# HISTORIC AND DESIGN REVIEW COMMISSION

**HDRC CASE NO:** 2022-315  
**COMMON NAME:** 1014 N CHERRY  
**ADDRESS:** 1012 N CHERRY  
**LEGAL DESCRIPTION:** NCB 512 BLK 25 LOT 6 HS  
**ZONING:** RM-6, H  
**CITY COUNCIL DIST.:** 2  
**DISTRICT:** Dignowity Hill Historic District  
**APPLICANT:** Ricardo Turrubiates/Mint Development LLC  
**OWNER:** DELAFIELD INVESTMENTS LLC  
**TYPE OF WORK:** Construction of six, 2-story residential structures  
**APPLICATION RECEIVED:** May 27, 2022  
**60-DAY REVIEW:** Not applicable due to City Council Emergency Orders  
**CASE MANAGER:** Edward Hall

## REQUEST:

The applicant is requesting a Certificate of Appropriateness for approval to construct six, 2-story residential structures on the vacant lots at 1012 and 1014 N Cherry, located within the Dignowity Hill Historic District.

1 TYPICAL WALL SECTION - STUCCO  
SCALE: 3/4"=1'-0"

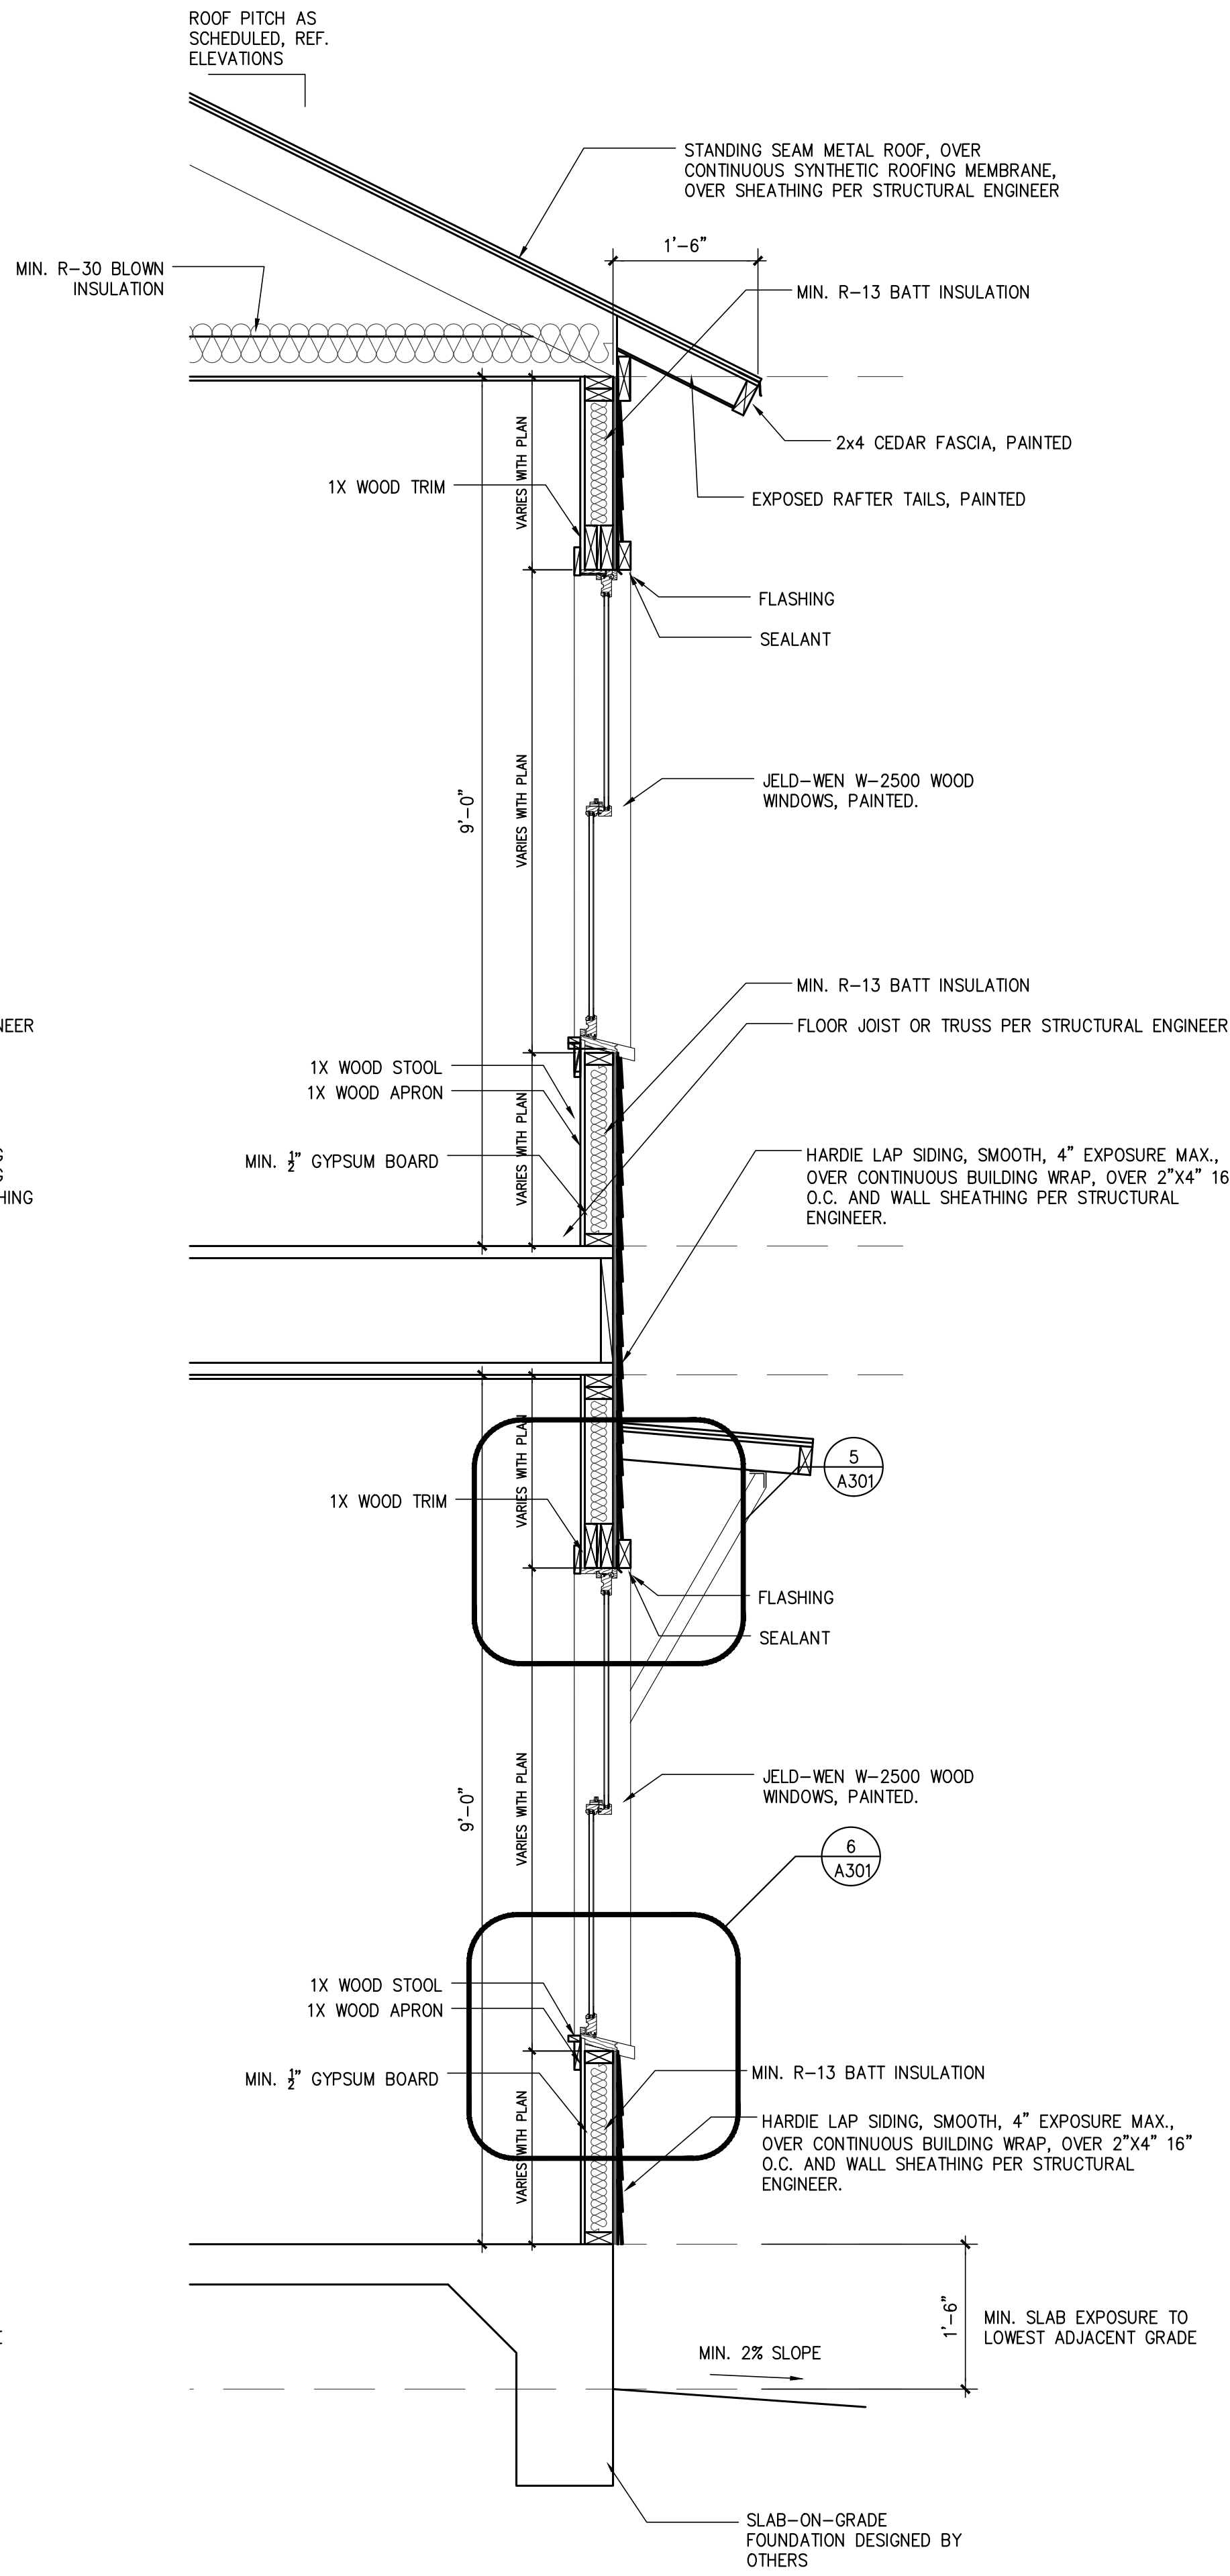
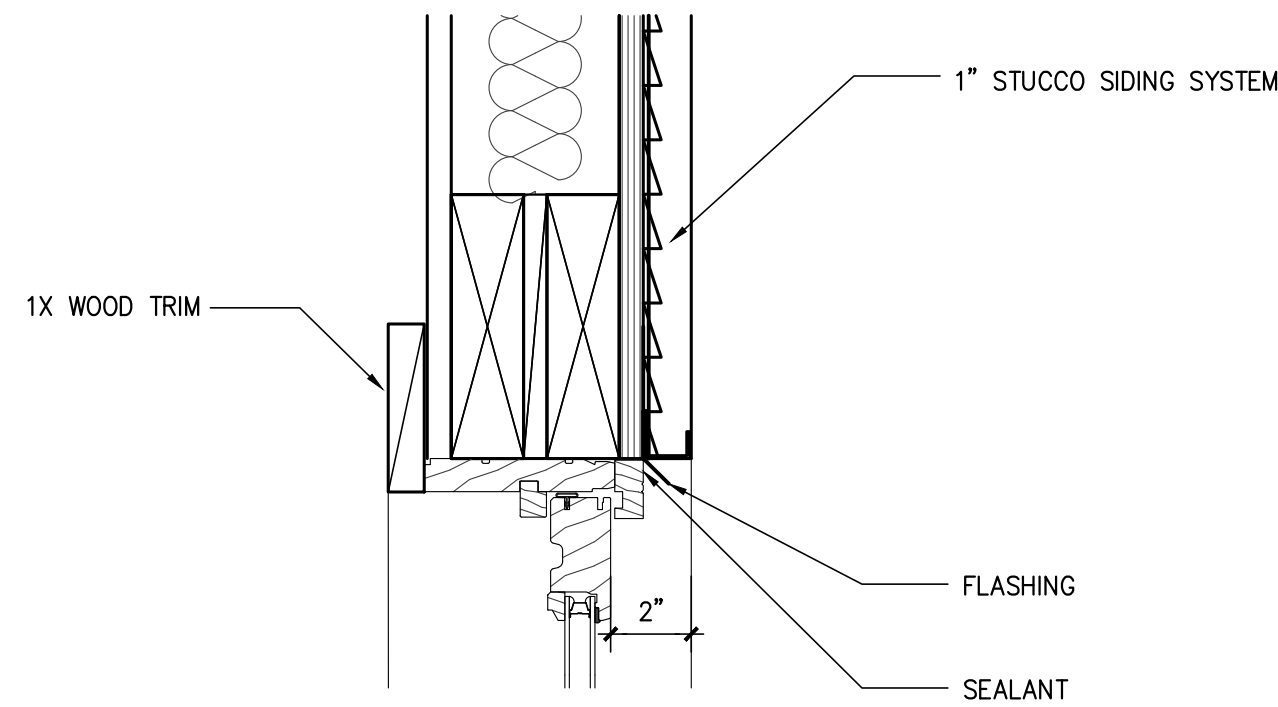
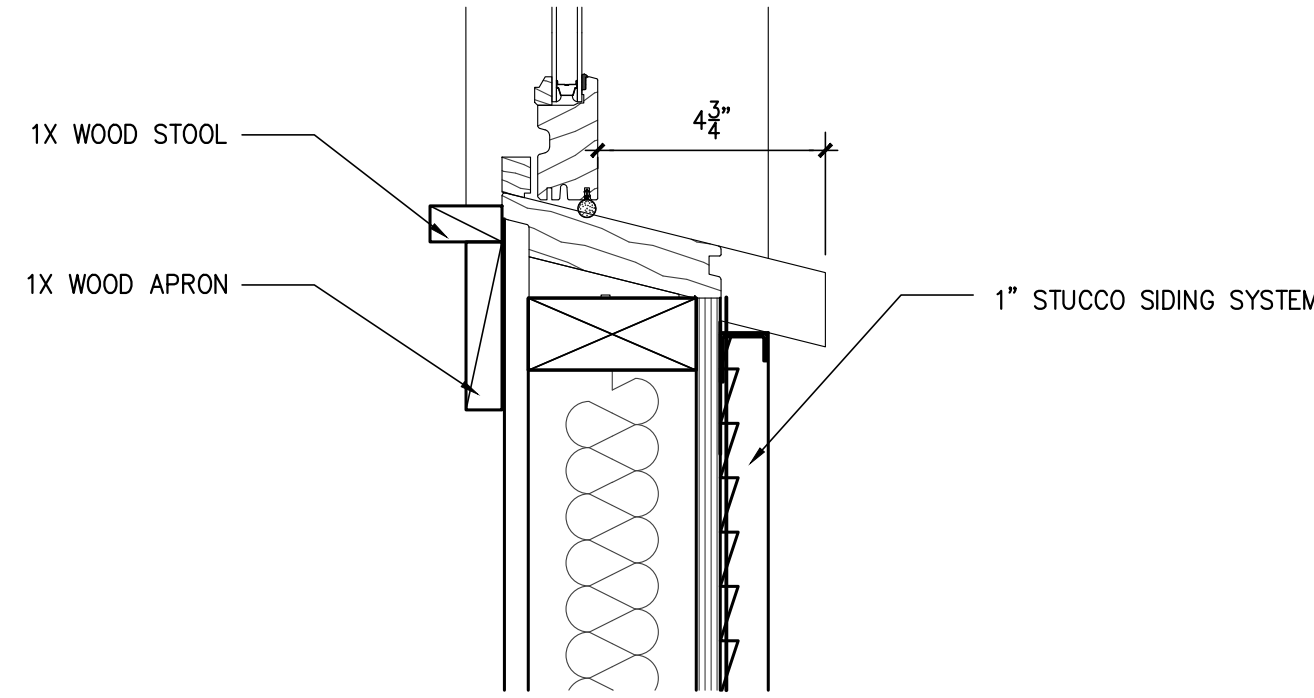
LG: Questions about window recess at stucco? No sections have been submitted to note this. Windows appear to be extrude from walls at stucco.
